CORRECTION

Correction: A smart multi-pipette for hand-held operation of microfluidic devices

Correction for 'A smart multi-pipette for hand-held operation of microfluidic devices' by Byeongyeon Kim et al., Analyst, 2016, **141**, 5753–5758.

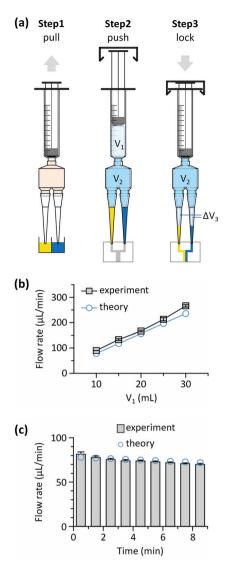
To reflect this change, amendments are required to Fig. 1 and the text.

- Fig. 1b and c are affected by the correction needed to the theoretical estimation for the generated pressure by the smart pipette, and the overall corrected version of Fig. 1 is as follows:
 - The first sentence on p. 5755 should be amended as follows:
- 'If $V_2 \gg (\Delta V_3)_t$ and $V_1 \gg (\Delta V_3)_t$, the pressure change becomes negligible and thus the smart multi-pipette maintains a constant pressure during device operation.'
 - The fourth sentence of the third paragraph on p. 5755 should be amended as follows:
 - 'We note that the experimental value is higher than the theoretical expectation of 7.8%.'
 - The changes do not affect any of the conclusions of the article.
 - The Royal Society of Chemistry apologises for these errors and any consequent inconvenience to authors and readers.
